**NOTICE OF INTENT TO COMMENCE LARGE MINING OPERATIONS &  
MODIFICATION OF PLAN OF OPERATIONS**

**LISBON VALLEY COPPER MINE**

M/037/0088

**Introduction Table 1 – Comments**

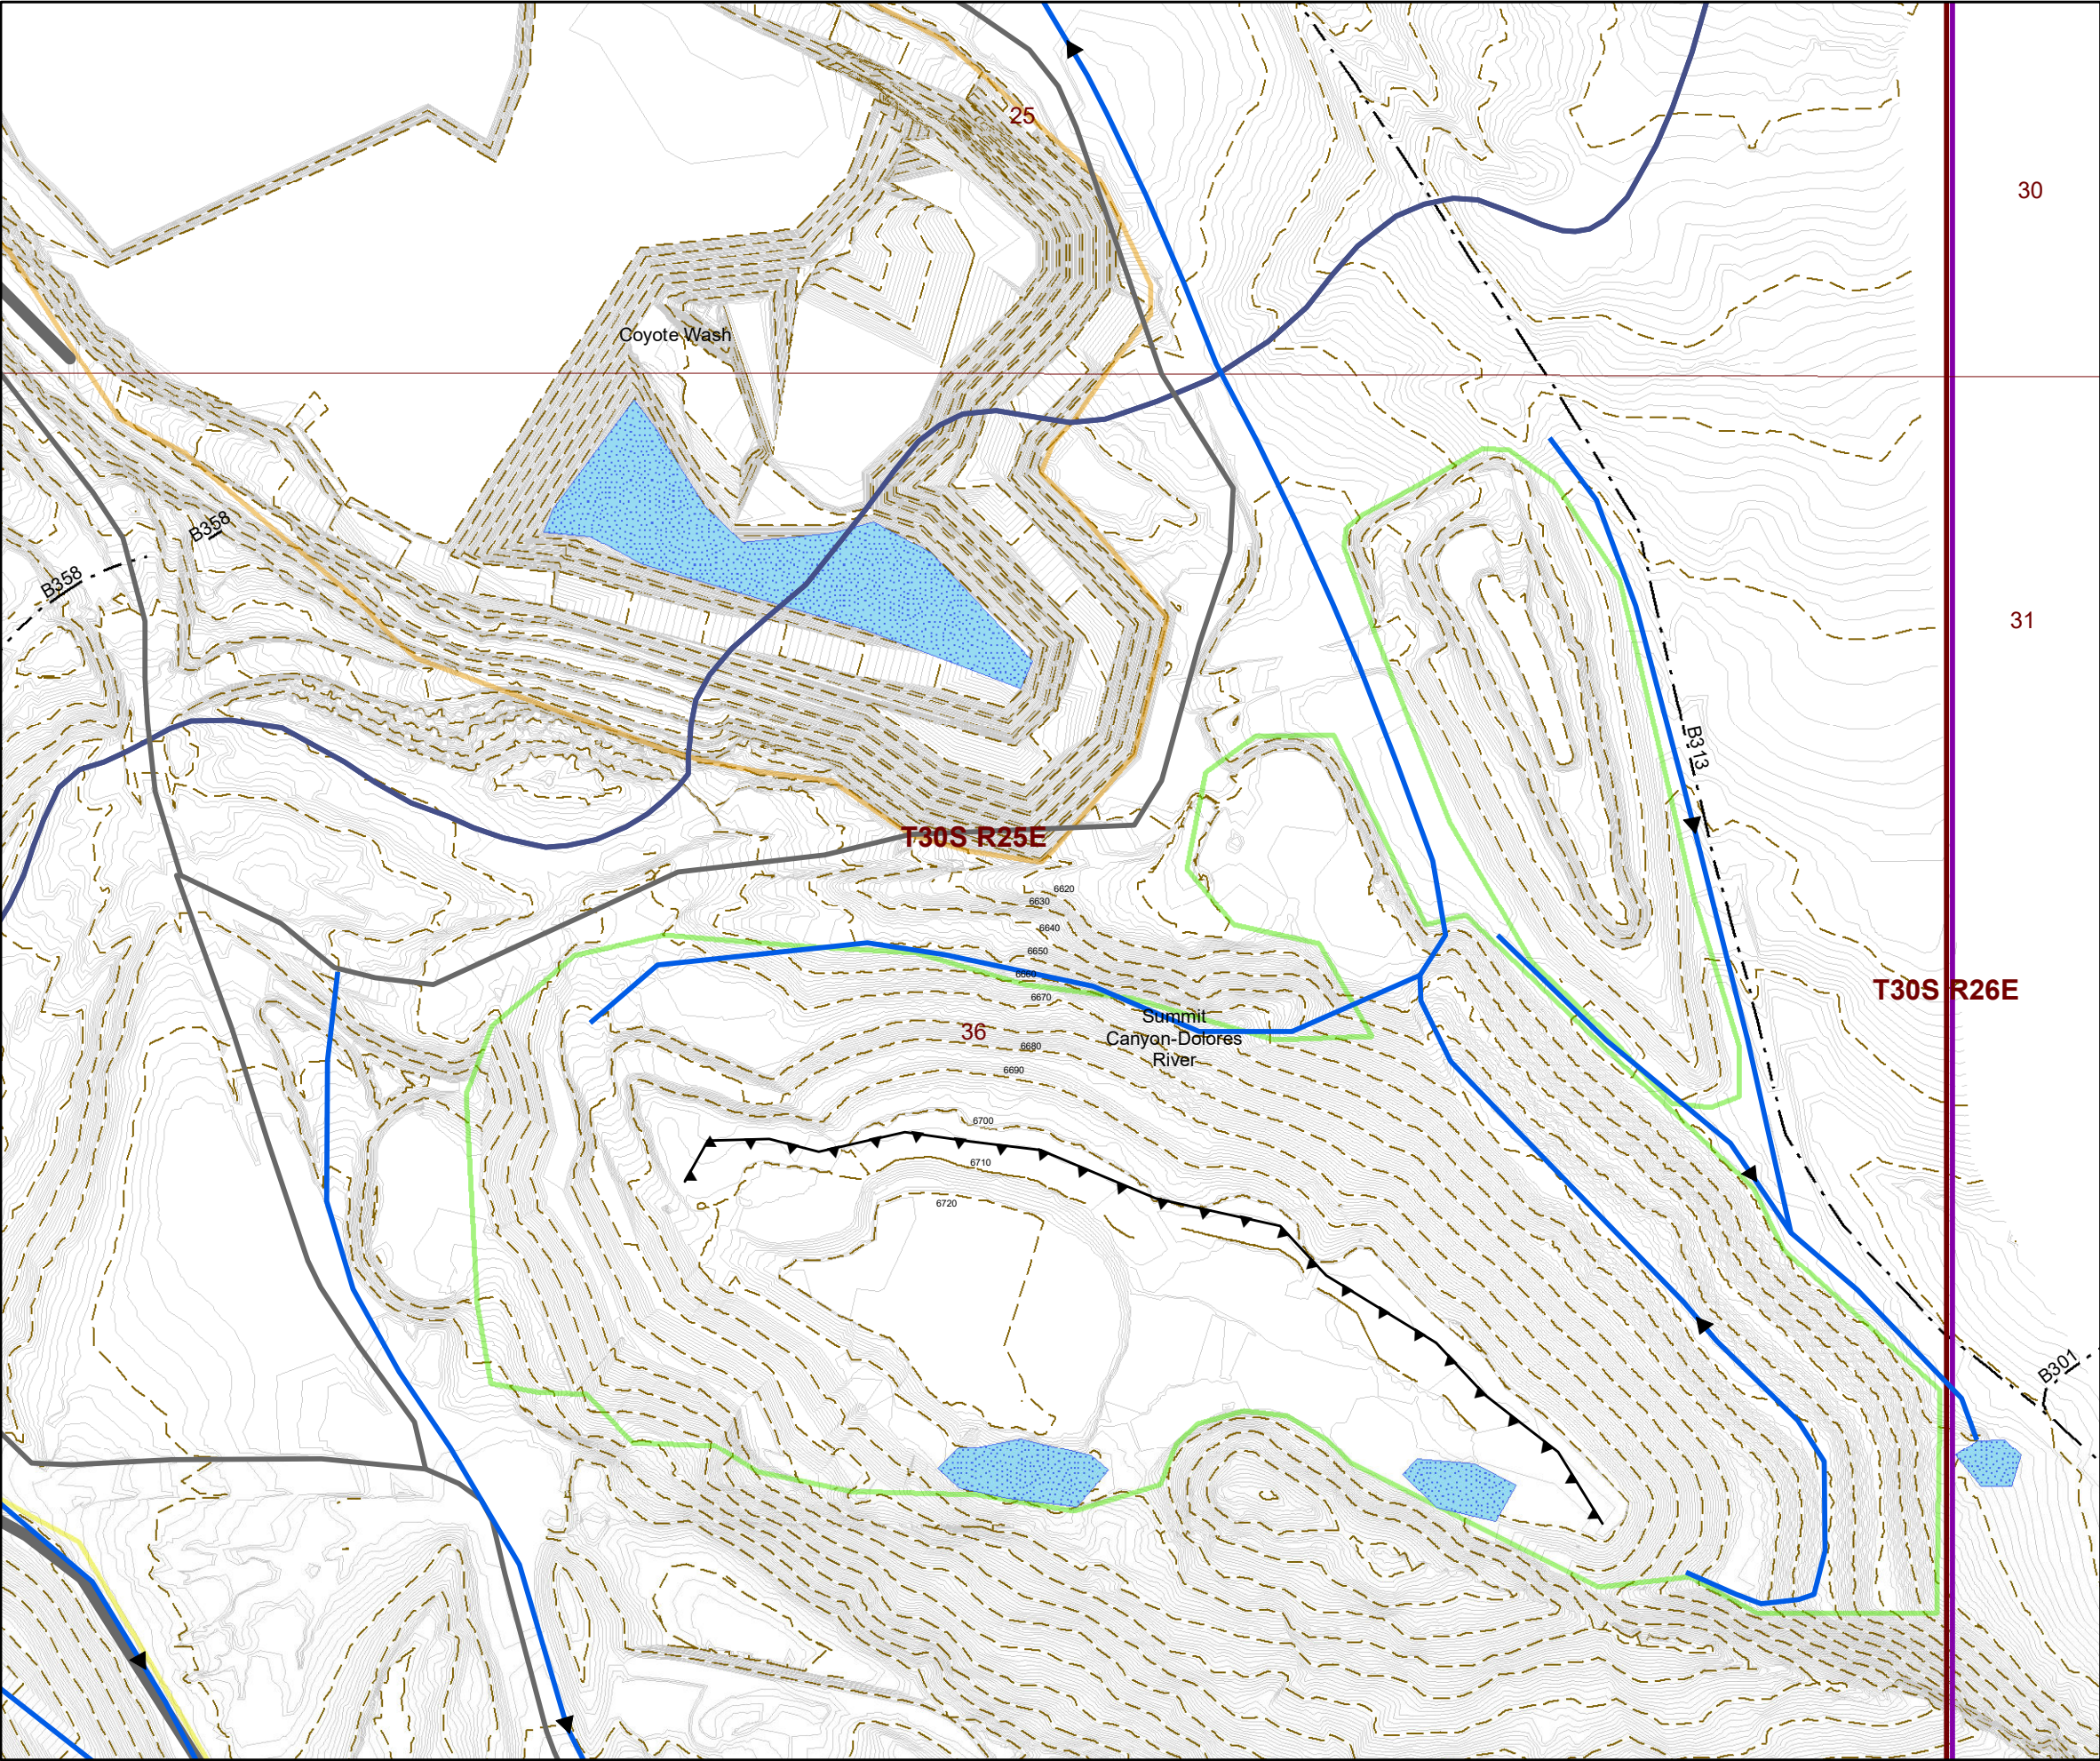
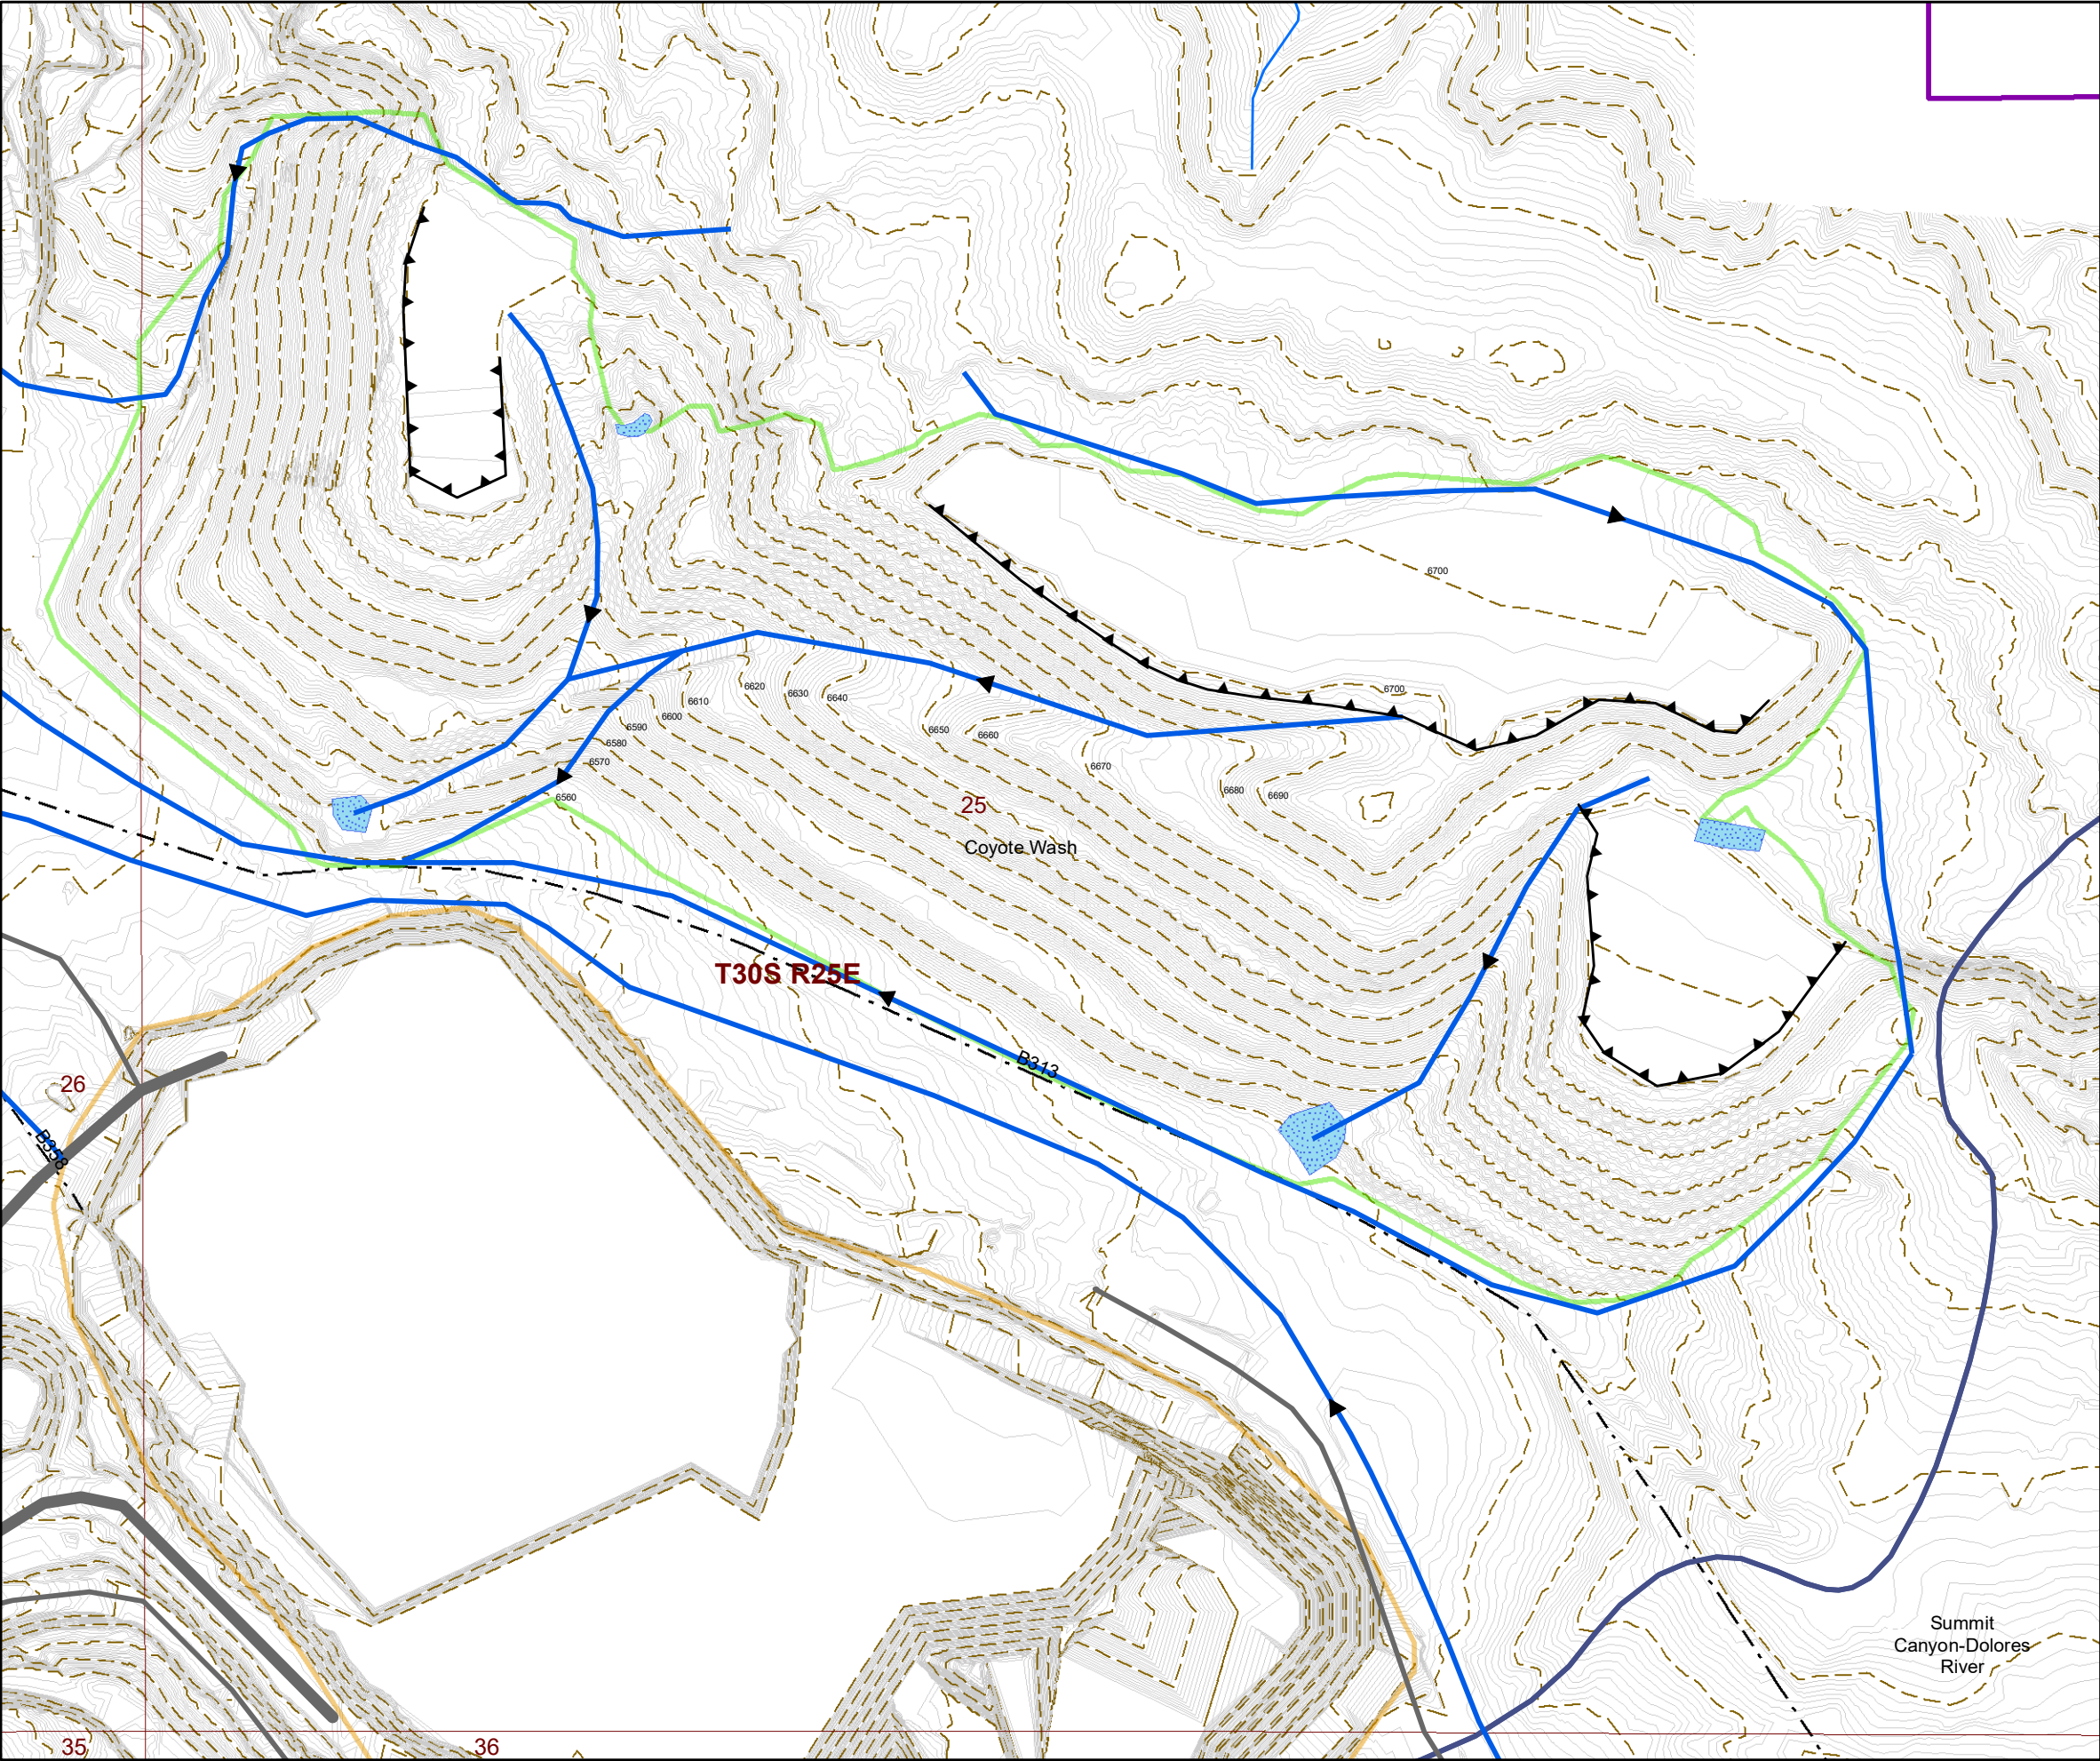
UDOGM Comment	Company Response	Response Location
Map 4, Hydrology – A new Map 4 has not yet been provided. As indicated in previous reviews, the existing Dump C channels are not acceptable in their current form. Watershed boundaries and associated acres are not included in previous maps. GTO areas planned for disturbance that may affect the grade and stormwater flow should be included within disturbance boundaries on this and other maps.	Map 4 has been updated to include the hydrologic features per the aerial flights and drainage processing performed by LVMC in February 2020. Modified drainage patterns have been mapped out for installation of riprapped drainage channels and associated catchment basins.	Appendix C
<p>Map 5, Reclamation Treatments (all maps) – Consistent with the discussion in section 110 (reclamation plan), include the following:</p> <ol style="list-style-type: none"> <li>1) Identify berms around pit highwalls (not just at access points), as requested above. Fencing alone is not considered adequate for long-term public safety.</li> <li>2) Indicate whether pond HDPE liner will be removed or modified (including to receive any graded heap leach pad slopes)</li> <li>3) Identify the depths of soil replacement, as well as compacted clay and inert waste rock thickness on the heap.</li> <li>4) Identify soil replacement on haul roads. Ripping alone is not likely to be successful since the roads probably contain contaminants that would inhibit vegetation.</li> <li>5) The Division recommends a single ripping of spread soil on the contours, since dozer track marks from grading are less likely to resist erosion over slope lengths such as these.</li> <li>6) Indicate that the landfill will be reclaimed consistent with Department of Environmental Quality (DEQ) requirements.</li> </ol>	<ol style="list-style-type: none"> <li>1) Berms have been identified around all pit perimeters. These are seen on the modified Map 5, Appendix C.</li> <li>2) Pond liner already ties into the leach pad liner via the east drainage ditch. No liner modifications are required for the ponds to receive graded leach pad slopes. Regarding the areas on the north where the slopes are not yet 2.5H:1V, these slopes are to be re-graded in 2021 in preparation for another lift. Although current leach pad slopes do show some areas that are not operationally 2.5H:1V, all slopes on the leach pad are capable of being re-graded to an overall 2.5H:1V slope when taking into account the pipe ditch at the toe of the pad slopes.</li> <li>3) Please see Map 5 for reclamation media layers.</li> <li>4) Please see Map 5 for reclamation media layers. Placement of topsoil on haul roads will only be performed if excess topsoil is available and if the roads do not serve a post-mine land use. Further, as the roads at the mine have not been treated with surfactants, very low risk of ‘contaminants’ exist on the roads, as all vehicle maintenance is performed at the designated Truck Shop.</li> <li>5) This is noted. Please see notes on Map 5 for reclamation practices.</li> <li>6) This language is located in Section 110 as well as on Map 5.</li> </ol>	Appendix C Section 110 Appendix I
